TRAFFIC AND PARKING IMPACT ASSESSMENT OF A RESOURCE RECOVERY FACILITY

344 Park Road-Wallacia

Traffic and Parking Impact Report

19m SEMI TRAILER VEHICLE SWEEP PATH PLAN
SITE INGRESS / EGRESS MOVEMENTS
PROPOSED SITE ACCESS DRIVEWAY
PROPOSED RESOURCE RECOVERY FACILITY
344 PARK ROAD, WALLACIA

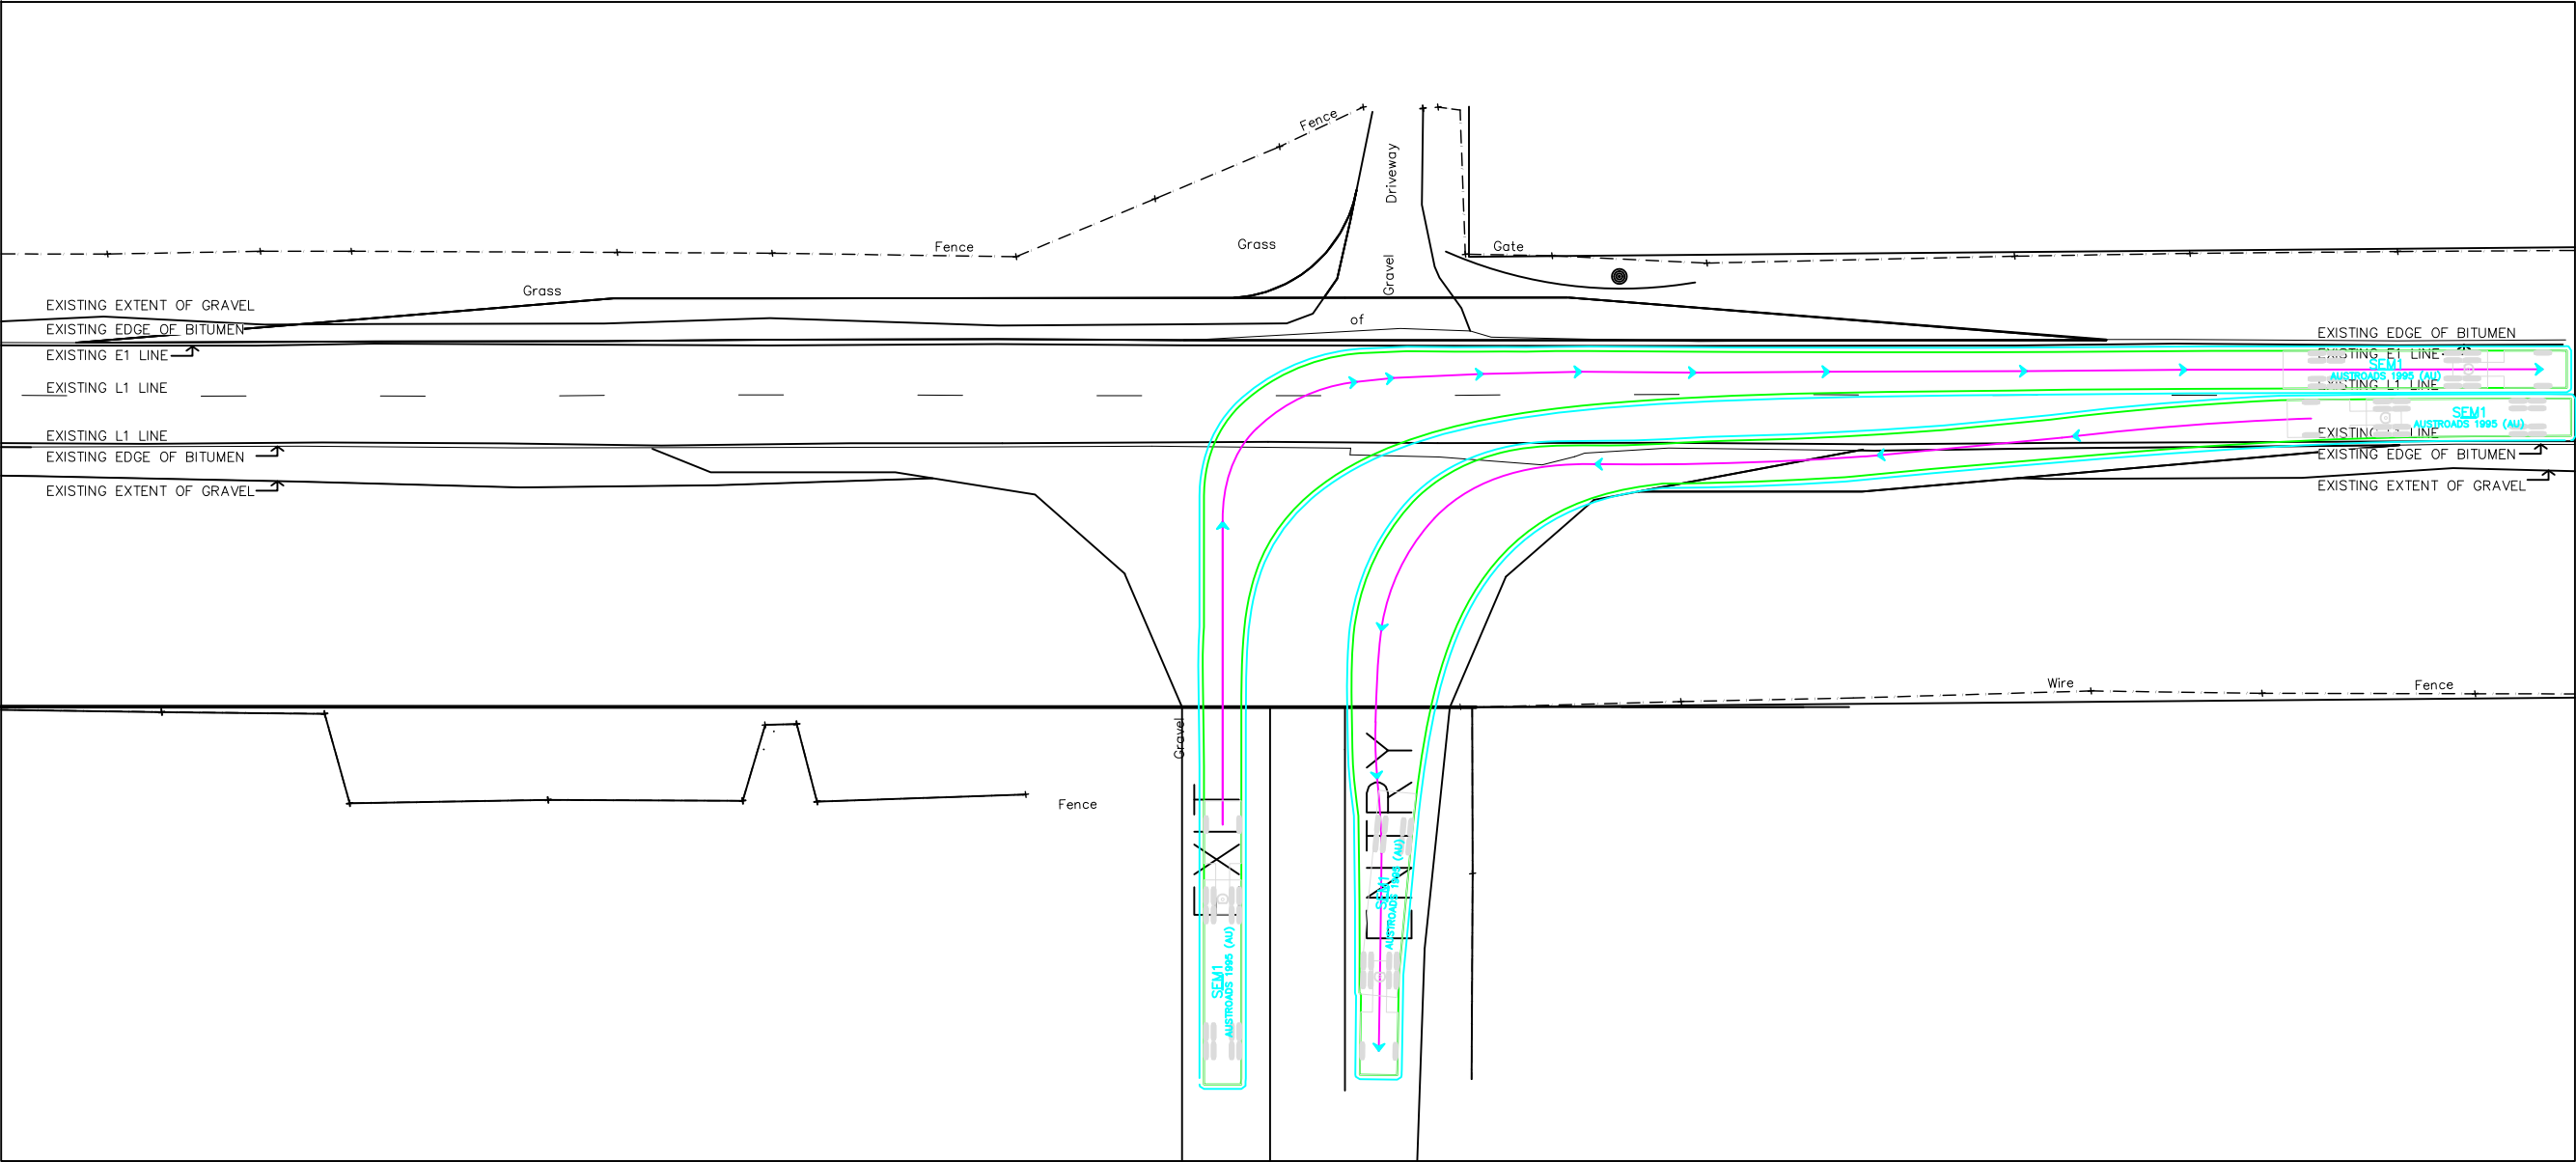
3. *TfNSW requests swept path plans for the longest vehicle accessing the site on Park Road for review. The plans should show how simultaneous entry / exit can be achieved at the access.*

In order to assess the suitability of the above recommended junction upgrade arrangements, a series of swept path plans have been prepared and are attached as **Appendix 3** for reference. These swept path plans illustrate the following:
